PIC24FJ64GB004 Family Silicon Errata and Data Sheet Clarification

The PIC24FJ64GB004 family devices that you have received conform functionally to the current Device Data Sheet (DS39940D), except for the anomalies described in this document.

The following typographic corrections and clarifications are to be noted for the latest version of the Device Data Sheet (DS39940D):

FIGURE 2-3 FREQUENCY vs. ESR PERFORMANCE FOR SUGGESTED VCAP

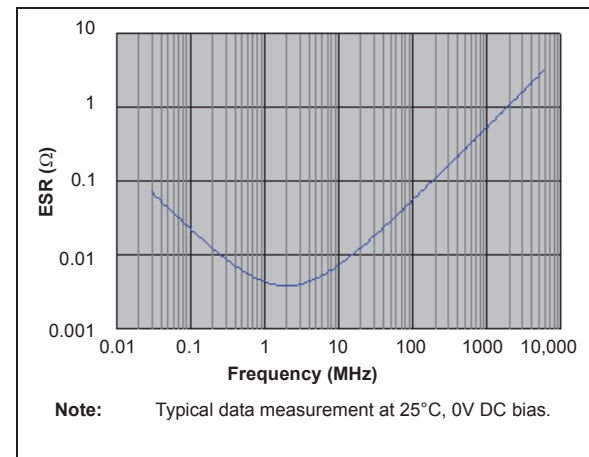
Section 2.4 Voltage Regulator Pins (ENVREG/DISVREG and VCAP/VDDCORE) has been replaced with a new and more detailed section. The entire text follows:

When the regulator is enabled, a low-ESR ($< 5\Omega$) capacitor is required on the VCAP/VDDCORE pin to stabilize the voltage regulator output voltage. The VCAP/VDDCORE pin must not be connected to VDD and must use a capacitor of 10 μF connected to ground. The type can be ceramic or tantalum. Suitable examples of capacitors are shown in [Table 2-1](#). Capacitors with equivalent specifications can be used.

Designers may use [Figure 2-3](#) to evaluate ESR equivalence of candidate devices.

FIGURE 2-4 DC BIAS VOLTAGE vs. CAPACITANCE CHARACTERISTICS

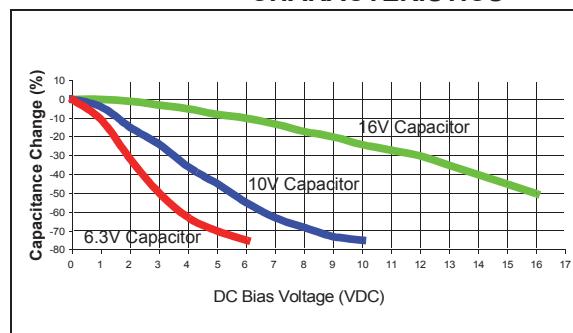
A typical DC bias voltage vs. capacitance graph for 16V, 10V and 6.3V rated capacitors is shown in Figure 2-4.

When selecting a ceramic capacitor to be used with the internal voltage regulator, it is suggested to select a high-voltage rating, so that the operating voltage is a small percentage of the maximum rated capacitor voltage. For example, choose a ceramic capacitor rated at 16V for the 2.5V core voltage. Suggested capacitors are shown in Table 2-1.

FIGURE 29-1: PIC24FJ64GB004 VOLTAGE-FREQUENCY GRAPH (INDUSTRIAL)

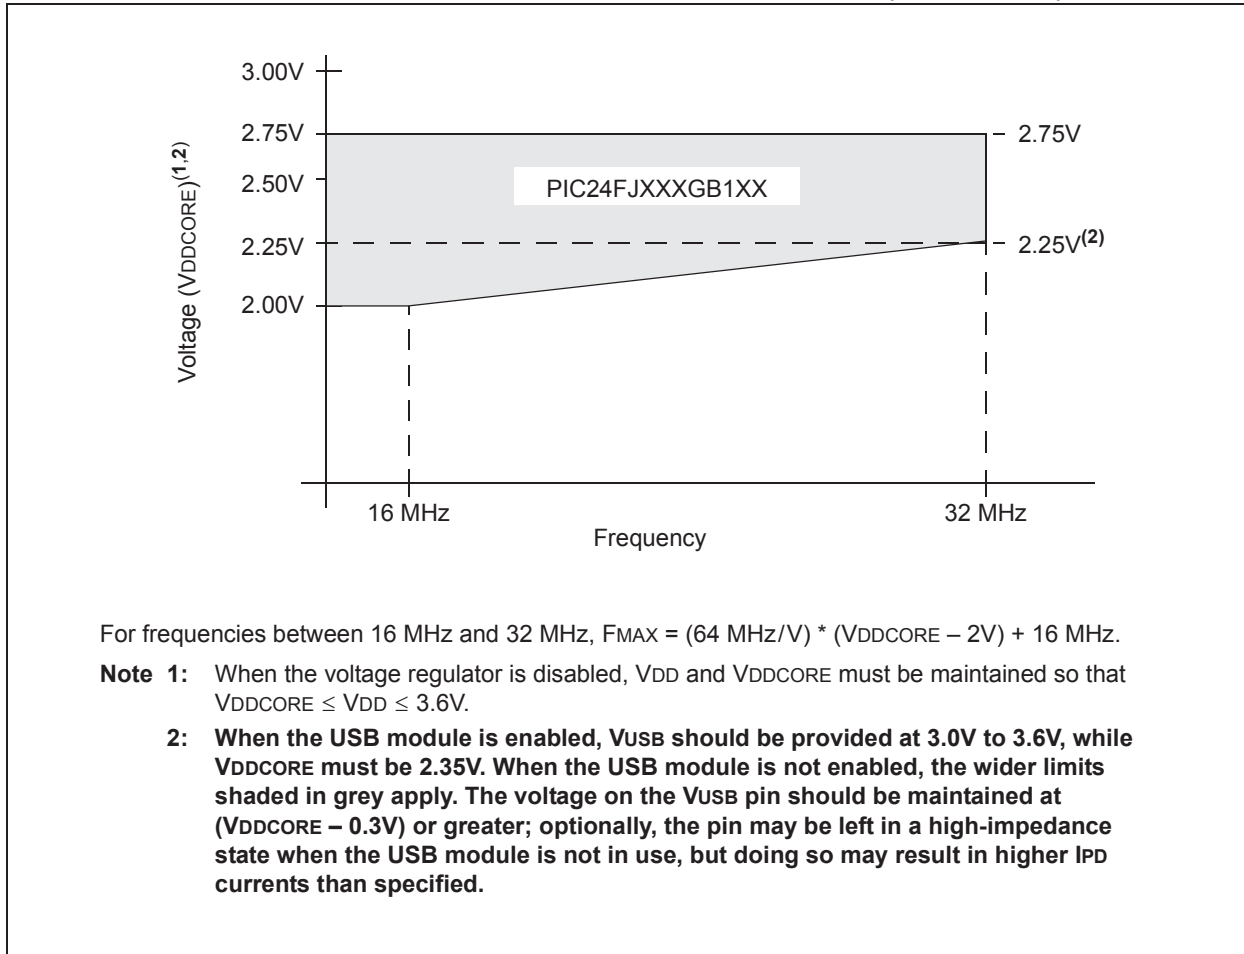
Figure 29-1 (“PIC24FJ256GB110 Family Voltage-Frequency Graph”) is amended by adding an additional footnote. The updated figure is shown below (changes in **bold**; bold in original removed for clarity).

28-Lead Plastic Small Outline (SO) - Wide, 7.50 mm Body [SOIC]

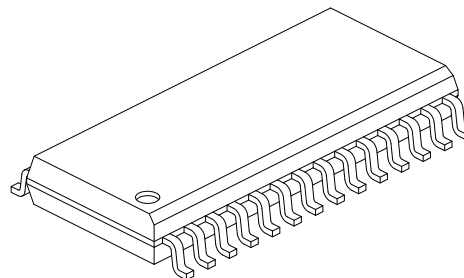
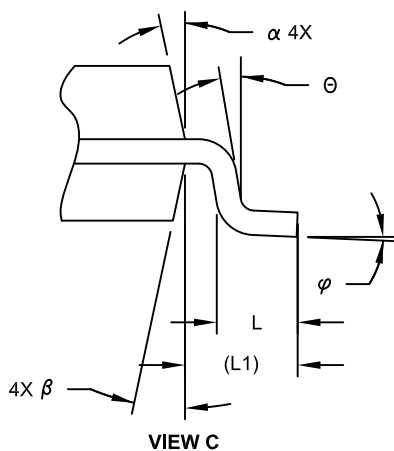
Section 30.0 “Packaging Information” omits the drawings for 28-pin SOIC packages (7.5 mm, type SO), which are a valid packaging option for this device family. The applicable Microchip drawings (C04-052C, two sheets, and C04-2052A) are added to the section. They appear on the following pages.
